RECALL 20V- 598: ENCODE CONTROL UNITS (REARVIEW CAMERA)

This Service Information Bulletin (Revision 4) replaces SI B66 14 20 **dated September 2020**.

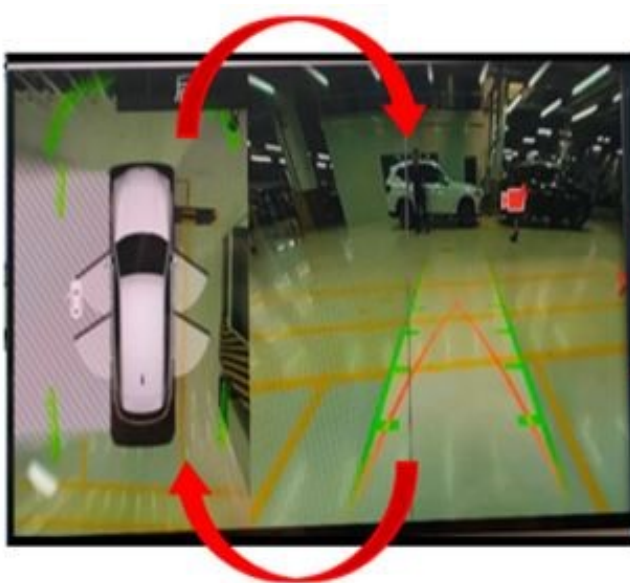
This picture shows a possible failure in vehicles equipped with option 6U3 (Live Cockpit Pro - incl. Navi).

The top view and rearview images are **incorrectly displayed** in the wrong position (swapped) on the CID.

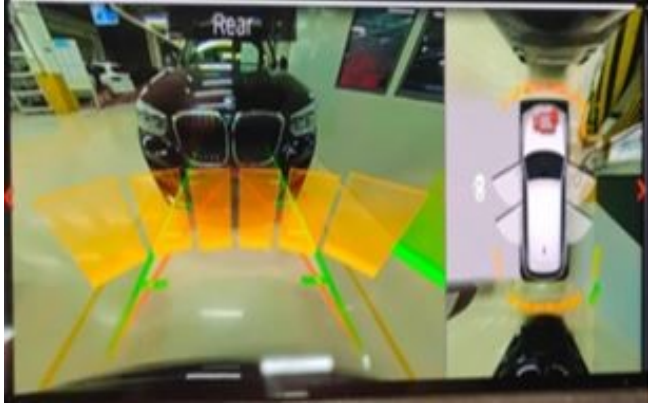
Here the images are displayed in the **correct image position** on the CID for vehicles equipped with option code 6U3 (Live Cockpit Pro - incl. Navi).

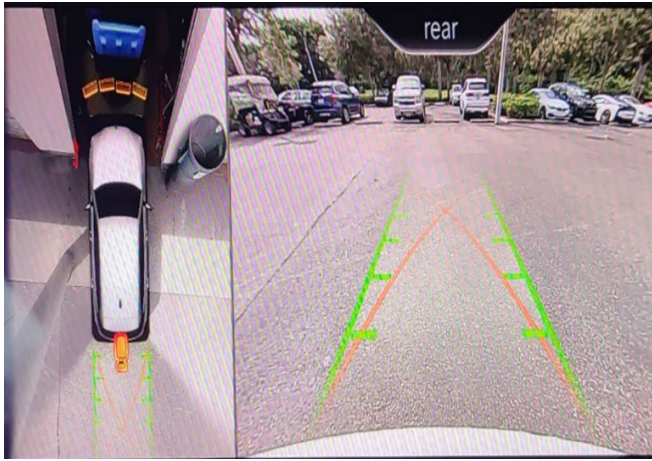
This picture shows the **correct image position** for vehicles without option code 6U3.
